**MAJOR PROJECT ASSESSMENT:  
Homebush Bay Bridge  
Homebush Bay, between Wentworth  
Point and Rhodes  
(MP10\_0192)**

Director-General's  
Environmental Assessment Report  
Section 75I of the  
*Environmental Planning and Assessment Act 1979*

March 2013

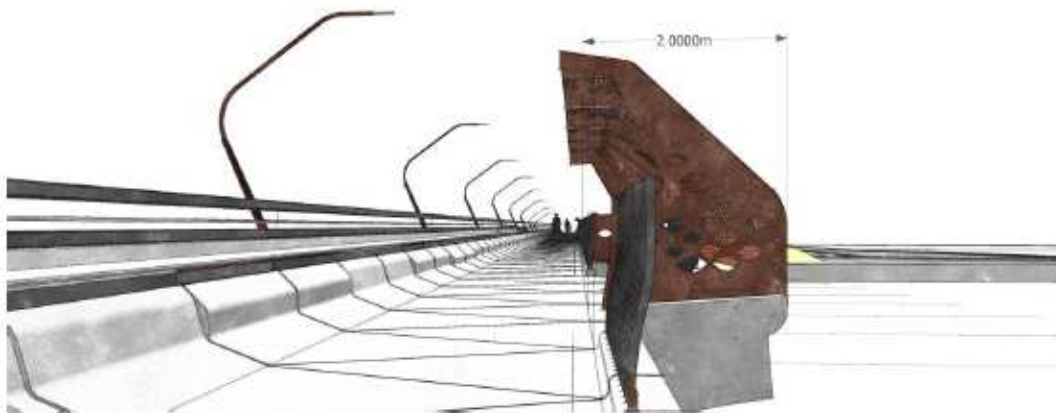
The bridge deck provides for separate pedestrian and cycle path and two lane bus road, separated by a 1.1 metre high (minimum) safety barrier. The road would be marked 'bus only', and restricted to bus and emergency and service vehicle traffic. The pedestrian and cycle path would be located on the north side of the bridge deck. The proponent has committed to a minimum clear path width of 3.25 metres, with rest areas set back from the proposed path. The bus lanes would be located on the southern side of the bridge deck.

The proposed deck configuration has been adapted in consideration of submissions from the community, TNSW and RMS. The original preferred lane configuration option in the EA (option 2c) proposed a two lane bus road with cyclist access, and separate pedestrian pathway. In response to agency and public submissions, the proponent identified in its response to submissions that the bridge deck would instead be configured to provide dedicated bus lanes and a shared pedestrian and cyclist path (option 2b).

The department considers that the final preferred option satisfies the need to avoid potential cyclist/bus and cyclist/service and emergency vehicle conflicts, and provide safe paths for young and inexperienced cyclists, by allowing cyclist access on a shared path separated from vehicular traffic. The department agrees with the proponent that further segregation of pedestrian, cyclist and bus movements, as requested by RMS, is not required to provide for further separation of bridge users, given that the bridge would provide a shared path width

suitable for recreational and commuter use. The department notes that, while more experienced cyclists would not be able to access the 'bus only' lanes, the shared path would provide an adequate width to allow commuter and recreational cycling. The department is satisfied that the proposed lane configuration is appropriate.

The department notes that RMS has emphasised the need to provide appropriate shoulder width along the shared path and bus lane. The department considers that the proponent has generally maximised the width of the shared path for use by cyclists and pedestrians, by committing to separating the proposed rest areas from the shared path. This would include installation of the rest areas as overhangs from the bridge deck (see **Figure 7**). The department considers that the proposed deck configuration, including the width of the bus lanes and shared path, is appropriate for the intended use of the bridge, particularly given the proposed shared path would meet minimum widths for recreational and commuter paths under the *Guide to Road Design Part 6A: Pedestrian and Cyclist Paths*.

**Figure 8 Rhodes peninsula foreshore public domain - indicative plan (Source: EA 2012)**

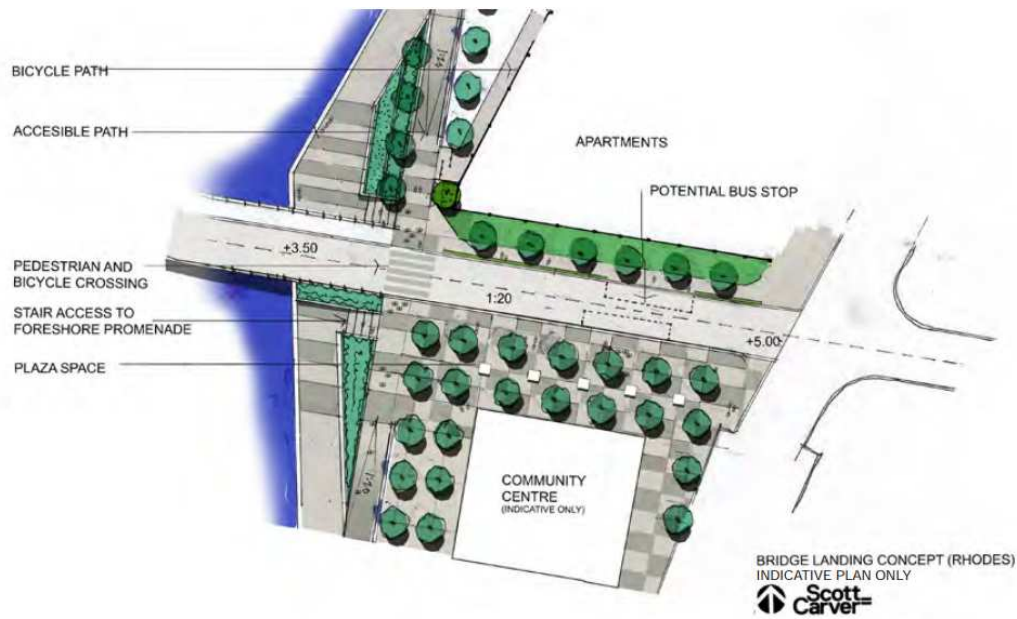
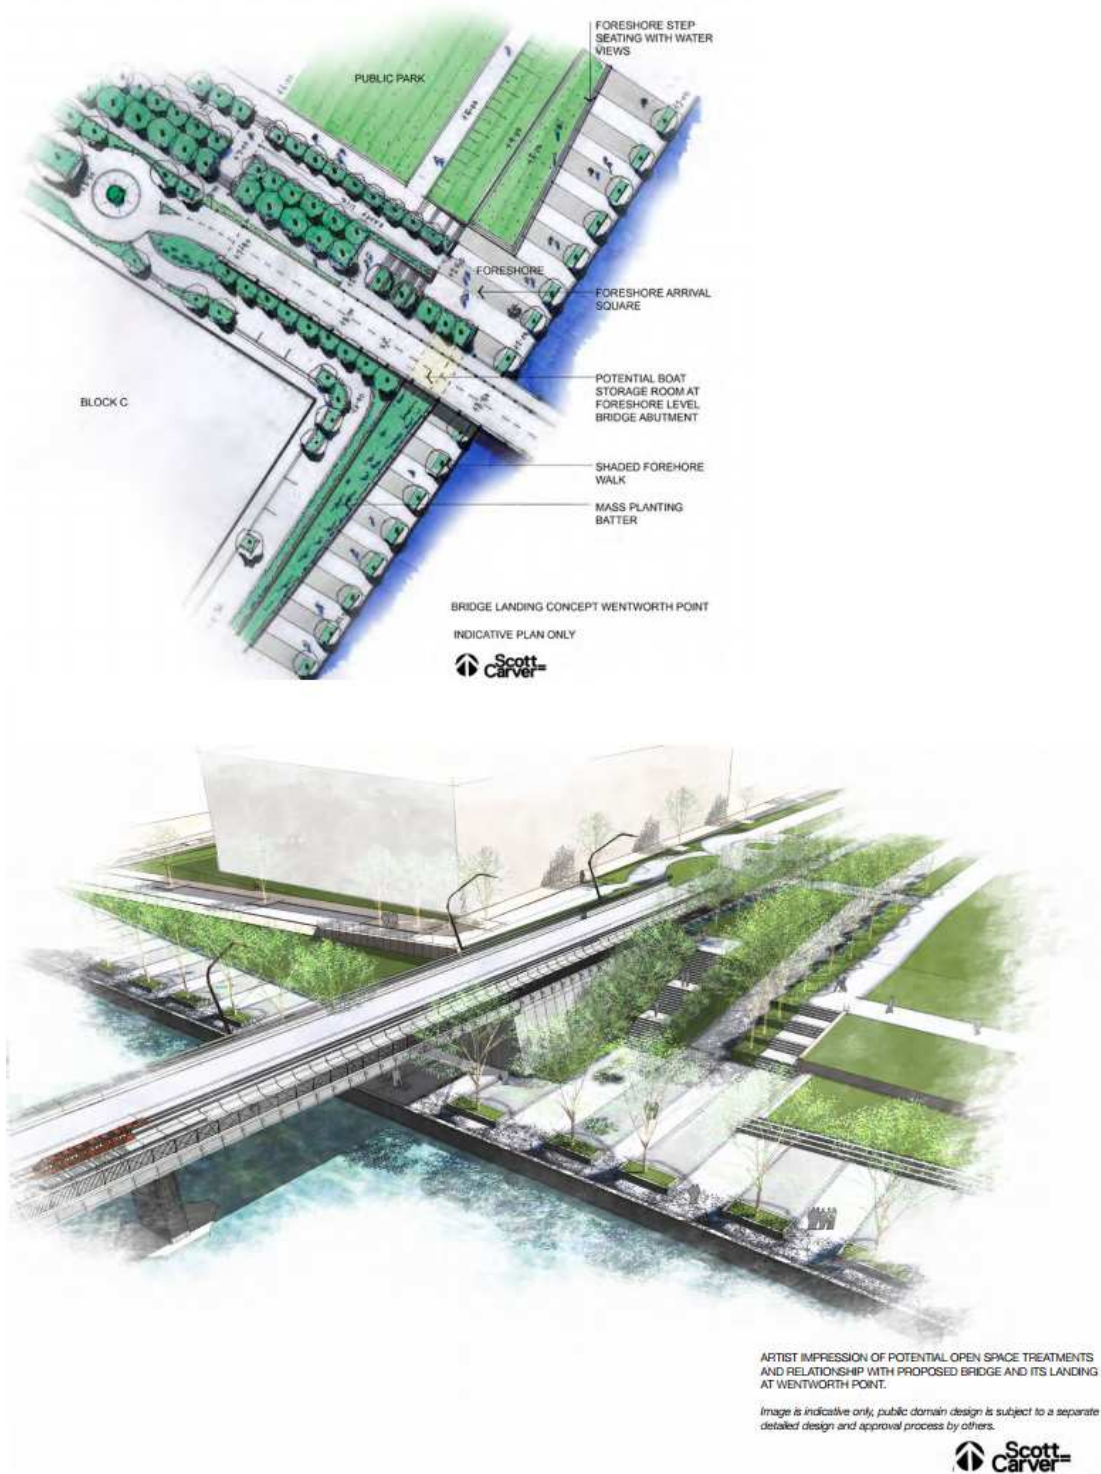
The indicative plans for the bridge approaches at Rhodes and Wentworth Point provide an appropriate general indication of the interface between the bridge and the Homebush Bay foreshore. The department, however, acknowledges that while the detailed design of the bridge is to be determined, there remains a need to ensure that the bridge is designed in a manner appropriate for the local area. In particular, the department acknowledges City of

Canada Bay Council's concerns, raised following review of the RtS, regarding integration of the bridge approach with the Rhodes Community Precinct on Shoreline Drive and Gauthorpe Street. In response, the department has recommended a number of conditions to provide additional certainty prior to construction regarding the final built form of the bridge and its integration with the existing and proposed landscape. The department has recommended a condition requiring the proponent to prepare an urban design and landscape plan for the proposal, in conjunction with agencies including Auburn City Council, City of Canada Bay Council and RMS. The plan would provide an integrated urban design outcome by detailing proposed landscaping, external materials and finishes, and public art in accordance with the *City of Canada Bay — Public Art Strategy 2008-2013*. The department has additionally recommended a condition that would require the proponent to prepare a lighting plan for the proposal. Further, the department has recommended a condition requiring provision of access for people with disabilities. The department considers that these conditions would provide for appropriate integration between the bridge and its surrounds. Further, the department notes that City of Canada Bay Council supports the recommended conditions of approval.

**Figure 11 Representative operational noise receivers (Source: EA 2012)**

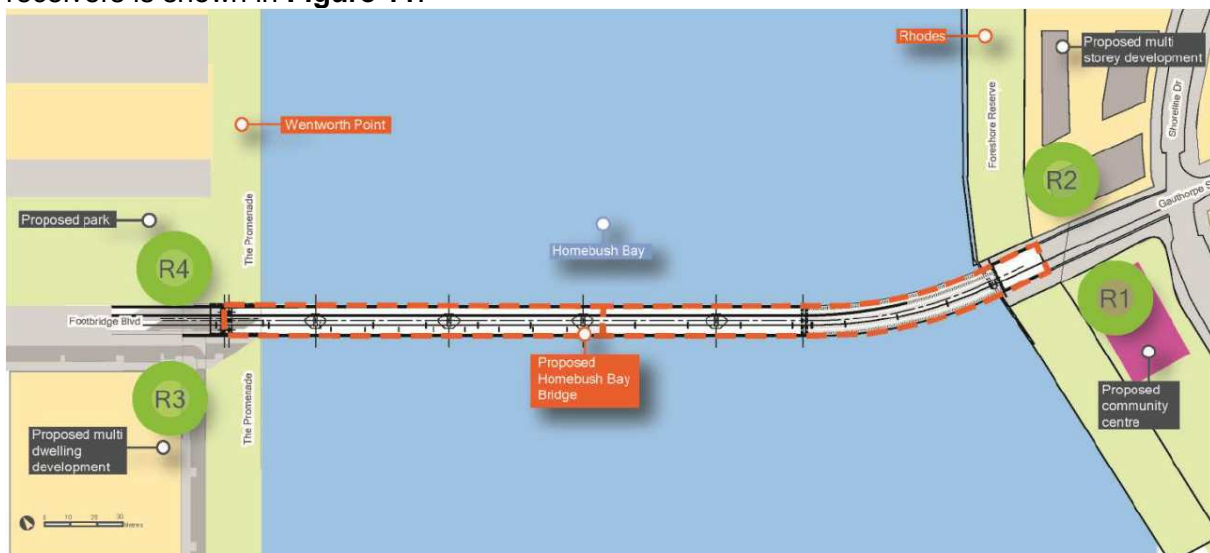
The Department notes that the receivers identified in Figure 11 and Table 7 comprise of:

The department acknowledges that noise impacts would exceed noise criteria for short periods during AM and PM peaks. To minimise the noise impacts of the proposal, the department has recommended a condition requiring the proponent to provide details of measures to monitor and manage noise impacts as part of the operational environmental management plan. This would include a requirement that the proponent undertake an operational noise report, including noise monitoring once operation of the bridge commences to verify the accuracy of the modelling, and a review of the appropriateness of mitigation measures. Should the proponent identify that the proposed mitigation measures would not provide appropriate reduction of operational noise impacts, the department will require details of any additional proposed noise mitigation.
